Access Compliance Report

Public Rights-of-Way

(Curb Ramps)

Intersection ID: 28107	Main Street: KNIGHTSDALE_DR	Cross Street: MITCHELL_GLEN_DR	Location: SW
ADA ID: 48A2F082B81D	Ramp Type: BlendTrans2	Initial Pass/Fail: Fail	Overall Compliance: No
Severity Score: 12.5			
Codes/Mitigation Info/Possible Solution		Field Measurements/Component Compliance

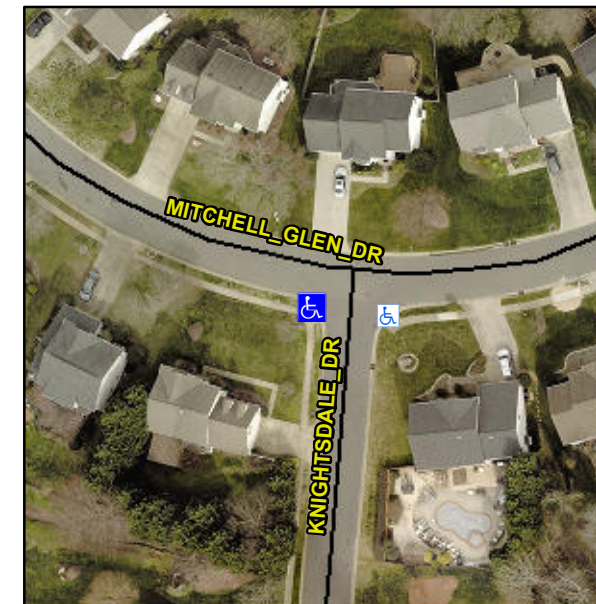
Not Found, R304.5.3

Compliance	Description	Data	Compliance	Description	Data
N/A	Ramp Length (in)	96.0	Yes	BlendTrans Slope (%)	4.3
Yes	Ramp Width (in)	49.0	No	BlendTrans XSlope (%)	5.4
N/A	Flare Type LT	N/A	N/A	Flare Type RT	N/A
N/A	Flare Slope LT (%)	N/A	N/A	Flare Slope RT (%)	N/A
N/A	Flare Traversable LT?	N/A	N/A	Flare Traversable RT?	N/A
N/A	Landing Length (in)	N/A	N/A	DWS Provided?	N/A
N/A	Landing Width (in)	N/A	N/A	DWS Contrast?	N/A
N/A	Landing Slope (%)	N/A	N/A	DWS Length (in)	N/A
N/A	Landing X Slope (%)	N/A	N/A	DWS Full Width?	N/A
N/A	Landing Curb? (Y/N)	N/A	N/A	DWS Offset (in)	N/A
N/A	Shared Landing?	N/A			
N/A	Gutter Ponding?	N/A	N/A	Gutter Slope (%)	N/A
N/A	Gutter Lip Ht (in)	N/A	N/A	Gutter X Slope (%)	N/A
N/A	Painted X Walk1?	No	N/A	Painted X Walk2?	No
	X Walk 1 Direction	To E		X Walk 2 Direction	To N
	X Walk 1 Width (in)	N/A		X Walk 2 Width (in)	N/A
	X Walk 1 Slope (%)	0.8		X Walk 2 Slope (%)	0.8
	X Walk 1 X Slope (%)	1.4		X Walk 2 X Slope (%)	2.2

N/A	Ramp inside XWalk1?	N/A	N/A	Ramp inside XWalk2?	N/A
	Road Slope (%)	3.4		Clear Space?	N/A
	Road X Slope (%)	1.8	N/A	Clear Space to XWalk (in)	N/A
N/A	Any Obstructions?	N/A	N/A	Storm Grate/Utility Hazard?	N/A
	Obstruction Type			Storm Grate/Utility Type	
		N/A			N/A
			Yes	Surface Condition? (G/P)	Good
			No	Curb Slope (%)	11.3

Remove & Replace Curb Ramp With Two New Directional Ramps or Equivalent.
